**University of Southern Maine
Community Education Center
PORTLAND, MAINE
GMP Documents**

**ADDENDUM NO. 5
FEBRUARY 2, 2004**

PEDESTRIAN BRIDGE ROOF

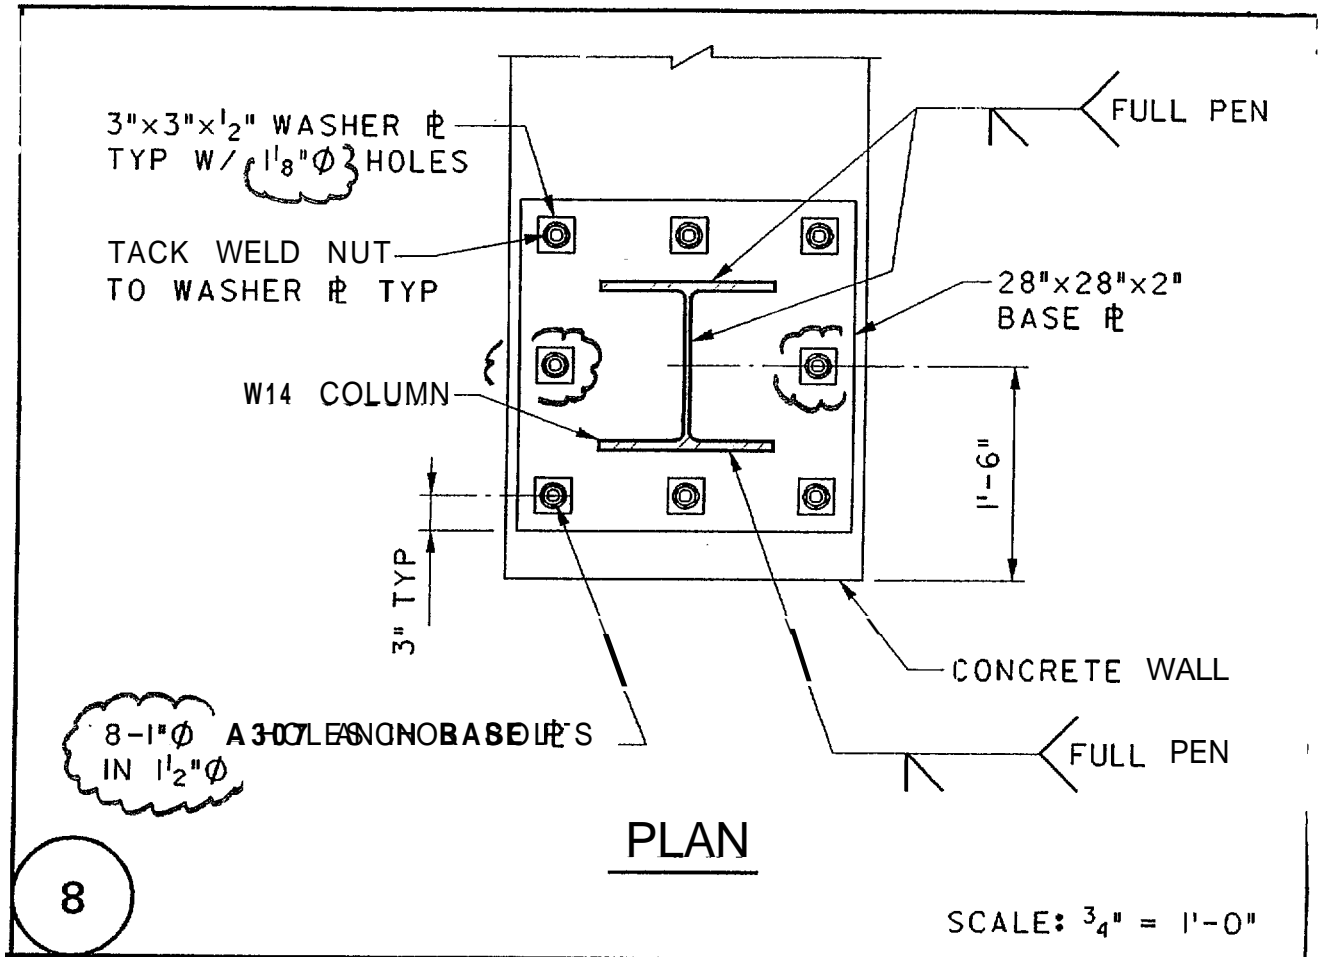
- A. Modify pedestrian bridge roof framing as shown on SKS-4 (attached).
- B. Revise Plan Detail #8 as per SKS-5 (attached).
- C. Revise Plan Detail #9 as per SKS-6 (attached).
- D. Revise Section Detail #11 as per SKS-7 (attached).
- E. Revise Notes as per SKS-8 (attached).
